Subject: Class II permissive change Request

FCC ID: 2AJJIAC00013

Augury improved the design of the Node 2.0 assembly (P/N: AC00013-WW) with of the shelf items as part of cost reduction efforts. Also, the removal of the thermistor cable (P/N: SA00010) and the screw which secure it (P/N: SC00018) improve the design for manufacturing.

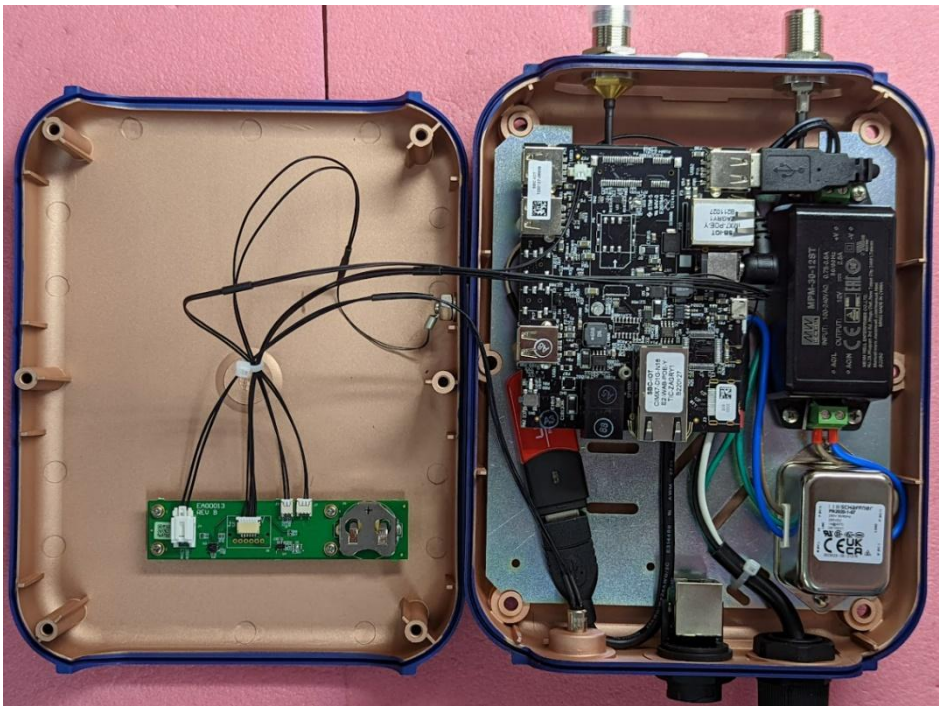
1. Remove the thermistor cable and its screw:
 - a. SA00010 - Thermistor assembly [Node]
 - b. SC00018 - Screw M2.5-0.45x5mm DIN 7985 Phillips PanHead SS
2. Replacing of the shelf items with the same specification:
 - a. CB00018 - Antenna mounting cable (15cm)
 - b. CB00026 - Antenna mounting cable NODE 2.0
 - c. CN00006 - Ethernet Connector (water proof)
 - d. GN00022 - Cable Gland M20 (with nut)
 - e. EL00023 - 5/7 dBi Outdoor Dual Band Omni Antenna Kit
 - f. CB00038 - USB 2.0 Extension Cable 1ft (30cm)
 - g. CB00031 - RJ45 Ethernet cable CAT6A 1ft

1. Removing the thermistor cable and the screw from the assembly

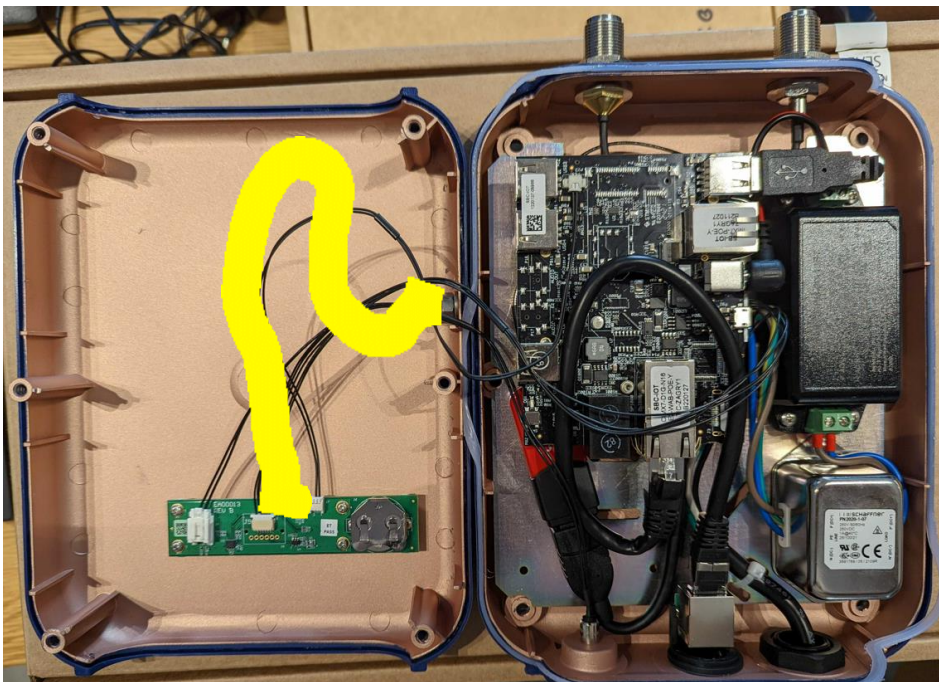
[Original:](#)

New:
